Notice of Intent

Sundry ID: 2698966

Procedure Description: OXY USA Inc. respectfully requests approved to amend the subject wells AAPD deep intermediate cement job to align with the agreed upon R111-P updates presented at the latest JITC meeting. See the attached updated cementing program and diagram for reference.

OXY USA INCORPORATED		
BATCH SUNDRY ID: 2698966		
PRECIOUS 30-18 FEDERAL COM	3H	3001546350
PRECIOUS 30-18 FEDERAL COM	32H	3001546611
PRECIOUS 30-18 FEDERAL COM	43H	3001546614
PRECIOUS 30-18 FEDERAL COM	44H	3001546544
PRECIOUS 30-18 FEDERAL COM	171H	3001546581
PRECIOUS 30-18 FEDERAL COM	172H	3001546582
PRECIOUS 30-18 FEDERAL COM	175H	3001546457
PRECIOUS 30-18 FEDERAL COM	176H	3001546462

Figure C] 4 – String – Un Cemented Annulus

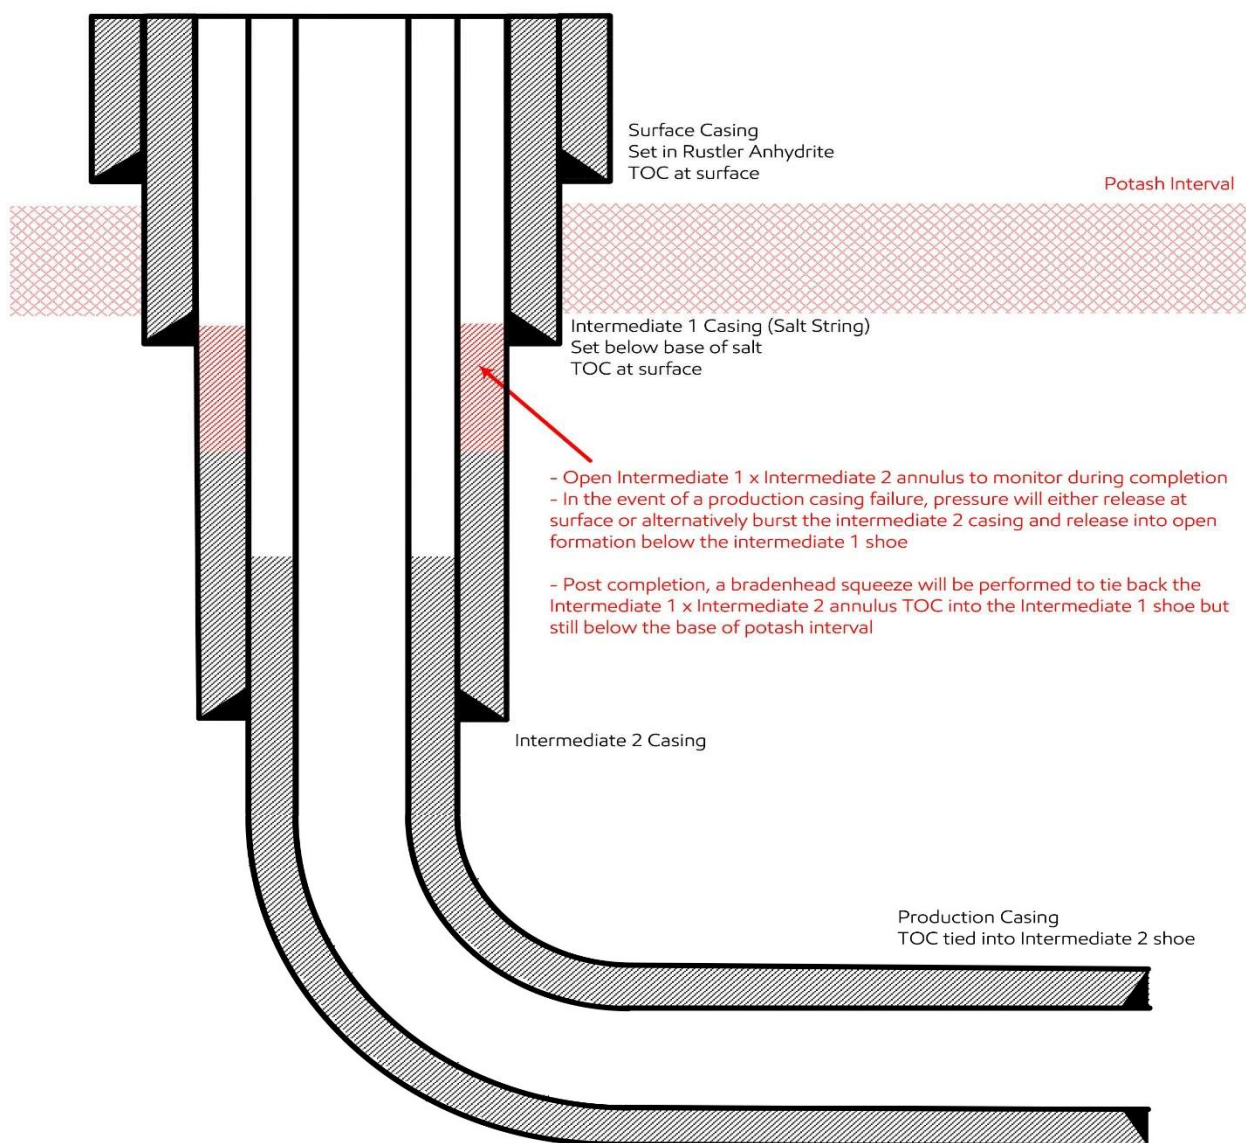
4-String Design – Open Int 1 x Int 2 Annulus

Oxy requests to update the Deep Intermediate Cement Job to align with the agreed upon R111-P updates presented from the JITC. (Below table based on Precious 30-18 Fed Com 175H)

**ALL PREVIOUS COAs STILL APPLY. CEMENT DESIGN UPDATE AS PER
KPLA BEST PRACTICES (4-STRING INT1 X INT2 OPEN ANNULUS)**

Operator has proposed to pump down 7-5/8" X 9-5/8" annulus POST-FRAC. Operator must top out cement after the bradenhead squeeze and verify cement to surface. Operator can also check TOC with Echo-meter. CBL must be run from TD of the 7-5/8" casing to surface if confidence is lacking on the quality of the bradenhead squeeze cement job. Submit results to BLM.
